# SMYRNA HISTORIC ZONING COMMISSION

**4TH ITEM: Adel Yacoub  
35 & 37 South Lowry Street**

## Adel Yacoub

### Staff Analysis

EXTERIOR ELEVATIONS

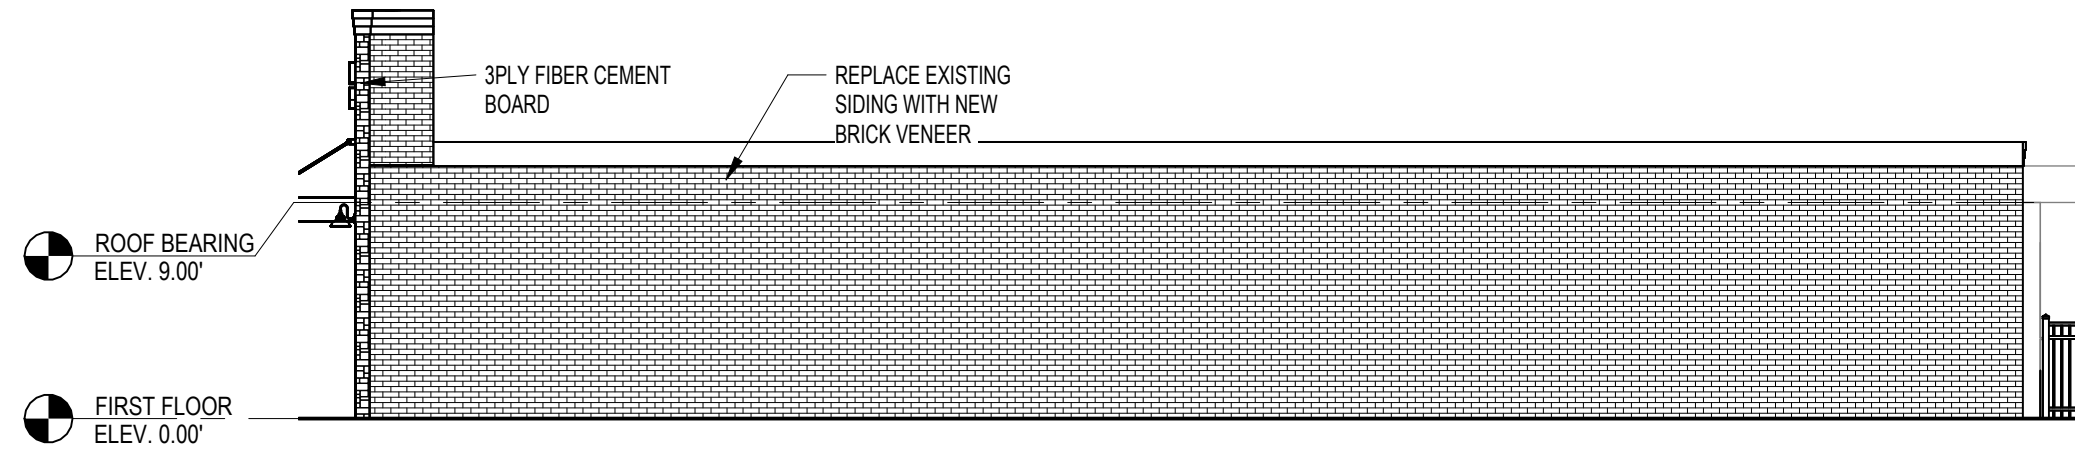
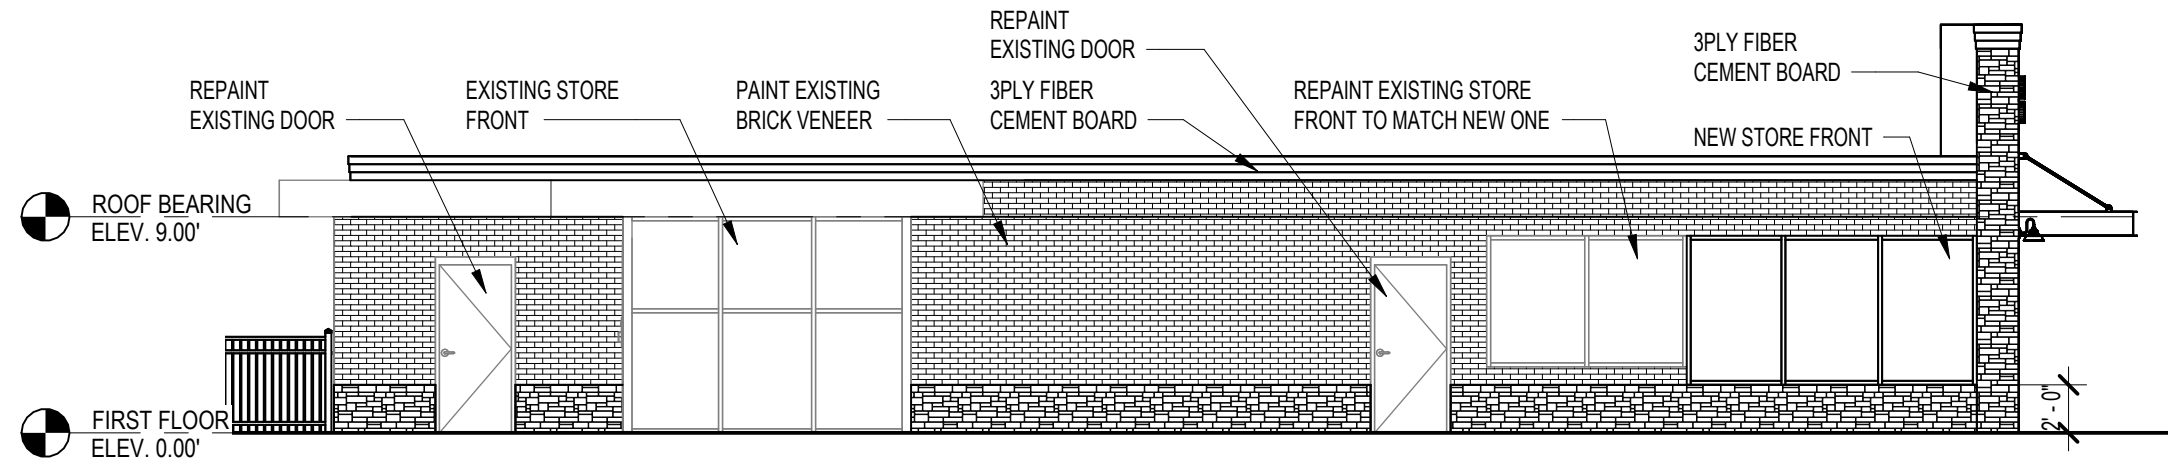
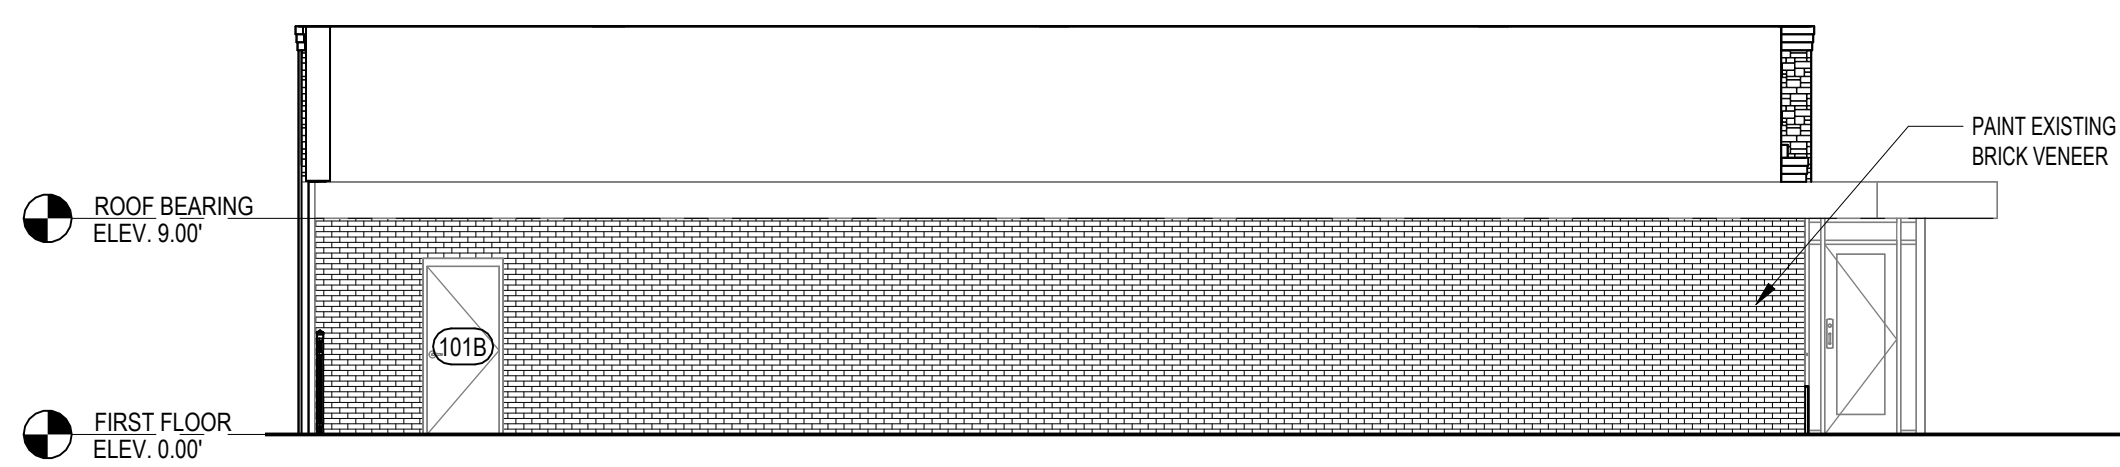
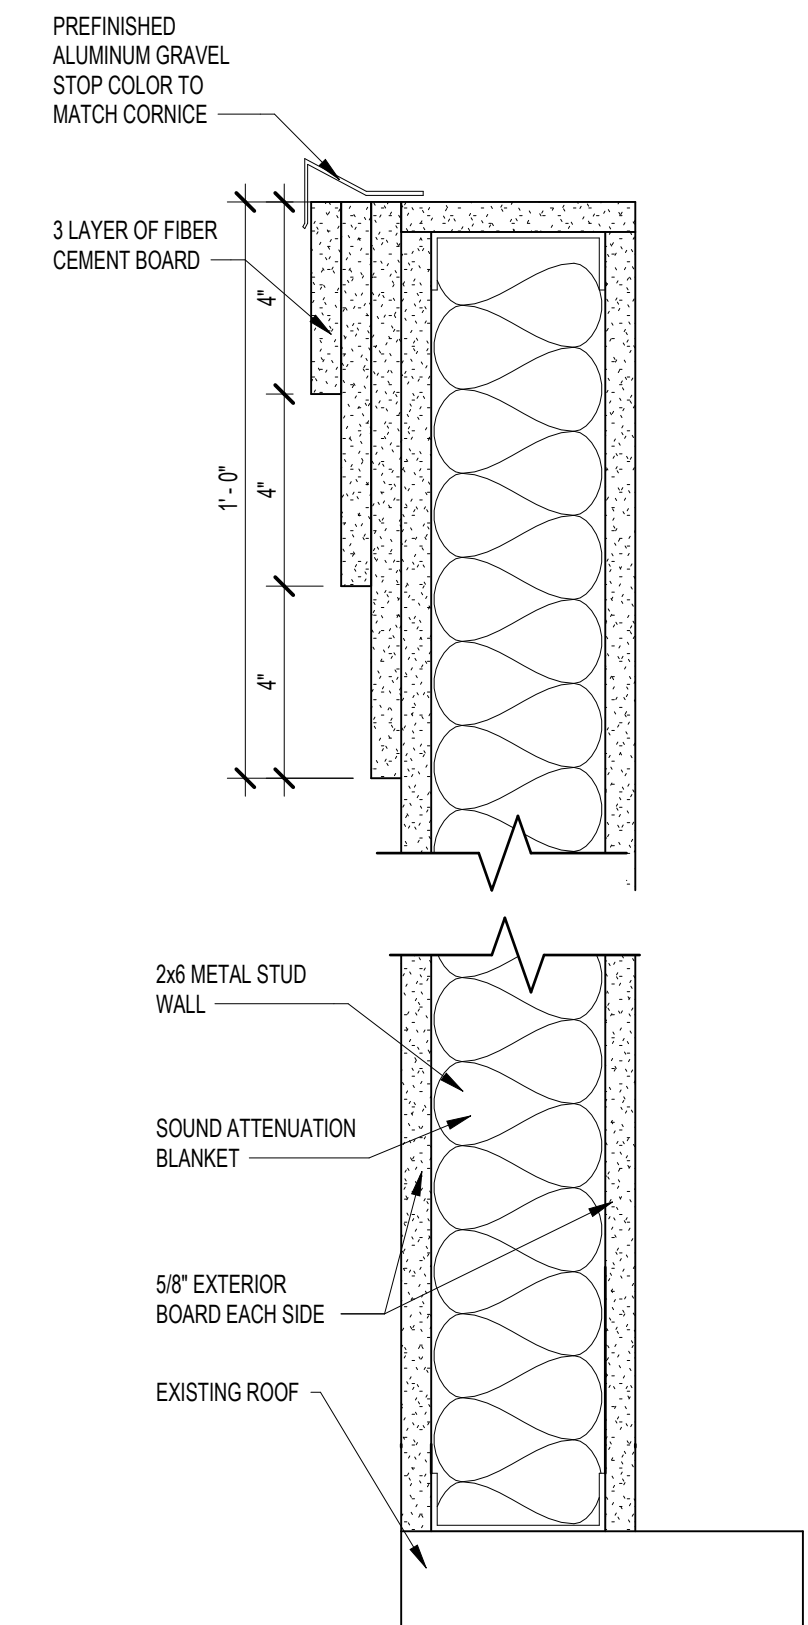
3. Replace Existing Brick - The existing building is primarily glass and brick. The applicant wishes to replace the existing deteriorated brick with new brick painted white, to replicate the appearance of the existing brick. The Front Street Historic Guidelines state the original building materials, including masonry, should be retained and if replacement is necessary, new materials shall match the design, dimension, detail and all visual characteristics of the original. In addition, the original details shall match the design of the original building.

4. Replace Doors/Windows - Front Street Guidelines state new doors shall fit the current opening; the applicant wishes to install all new doors and windows. The building has two suites on the front elevation with the left tenant having a two door entrance and the right tenant having a one door entrance. Applicant is showing new doors to fit in the same location as the existing door locations. Front Street Guidelines state number, location, size and glazing pattern of windows on primary elevations shall be retained. Renderings submitted show a similar style of window in the same location.

5. Stone Pilasters & Wood Slate - The existing building has primarily brick and glass, however, the applicant wishes to add stone pilasters (in one option) and wood slate behind the signage to the front facade. Front Street Guidelines note the original architectural details should be retained. The LSO permits primary materials to change on a horizontal line, which is shown around the base of the building on the S. Lowry Street and Tank Street facades. The applicant has submitted three variations of pilasters:

6. Extend Parapet - As part of the facade upgrade, the applicant wishes to extend the parapet, approximately 5 to 8 feet above the existing parapet and would be within 1 foot of the height of the adjacent commercial building to the north to create a uniform appearance. Front Street Guidelines recommend when new work is to be completed, it shall be compatible with the massing, size, scale, and architectural features of the existing to protect the historic integrity of the property and its' environment. Per the Lowry Street Overlay, buildings with flat roofs shall have parapet on all street-facing facades; the applicant is showing a new parapet along Tank Street to meet this requirement. The material for the parapet shall match the material of the associated facade.

10. Staff would recommend approval of the request with the removal of the stone accent and substituting it with the same brick color shown in options two or three due to the addition of stone to a building that is not currently clad with stone is against the recommendation of the Front Street Guidelines.
